Re: Evaluation of Radiological Parameters, Landfill Zone (Operable Unit 2)  
Follow-up to June 10, 2008 submittal and June 23, 2008 phone call

**Landfill Zone, Lowry AFB  
 Uraninite Saturation Indices  
 July 7, 2008  
 Follow-up to June 10 Letter  
 Lowry Assumption, LLC**

Elizabeth Sopher  
Senior Project Manager  
Attachments:  
Figure - Uraninite Saturation Indices  
Plots – Major ions vs. groundwater elevation

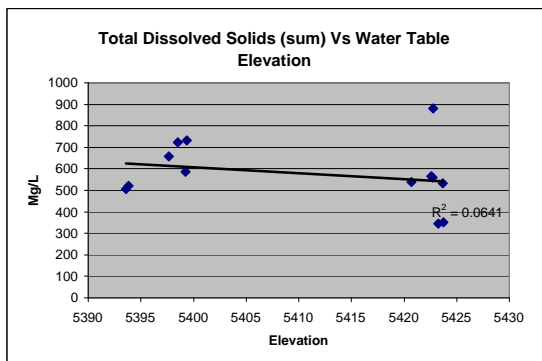
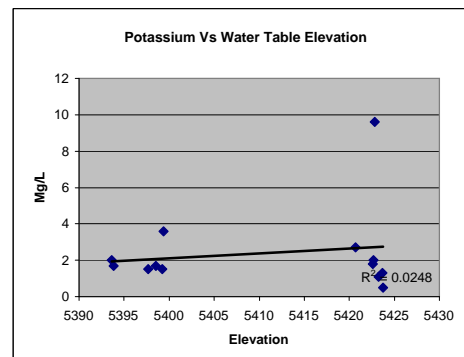
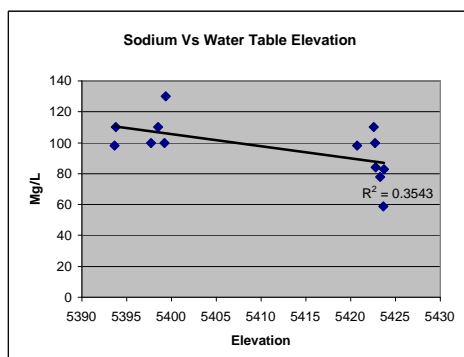
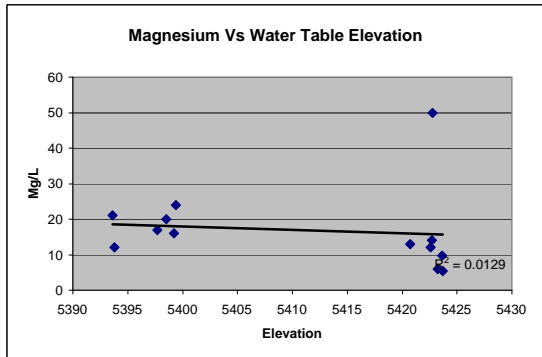
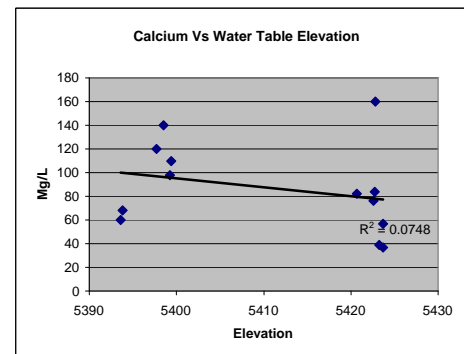
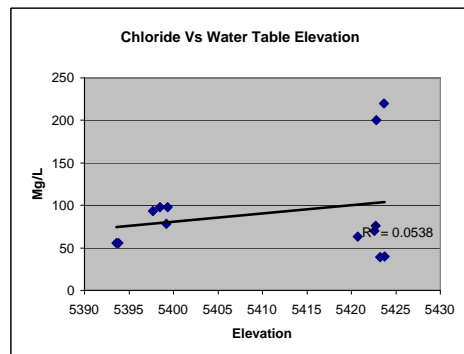
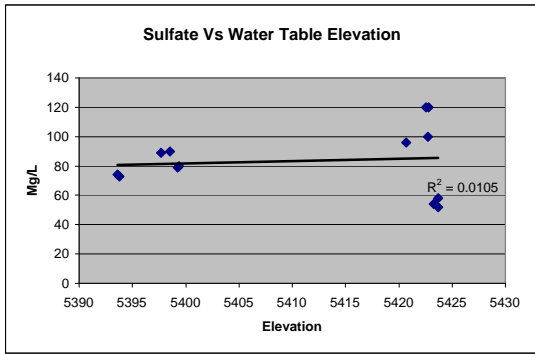
1. Does the geochemistry of the groundwater demonstrate that the upgradient and downgradient groundwaters have the same signature? And is there any significant trend in concentration along the flow path?
2. What does the aerial distribution of the saturation index data illustrate?

1. The geochemistry data demonstrate that the up and down gradient groundwaters are part of the same system, as illustrated in the attached plots of major ions in the groundwater versus groundwater elevation under OU2, which trends from 5430 ft to 5390 ft above MSL from the south to the north side of OU2. Wells to the east and west of the landfill zone (OU2) were excluded from this analysis to focus specifically on groundwater flow in and under the waste materials. As shown in the attached charts, concentrations show no significant change with flow across the landfill which is represented by groundwater elevation. The  $r^2$  values for each data set are shown on the plots, and none is above 0.1 except sodium (0.35), all demonstrating poor correlation. The plots show that there is no statistically significant or systematic trend of concentrations of major ions in the direction of groundwater flow.
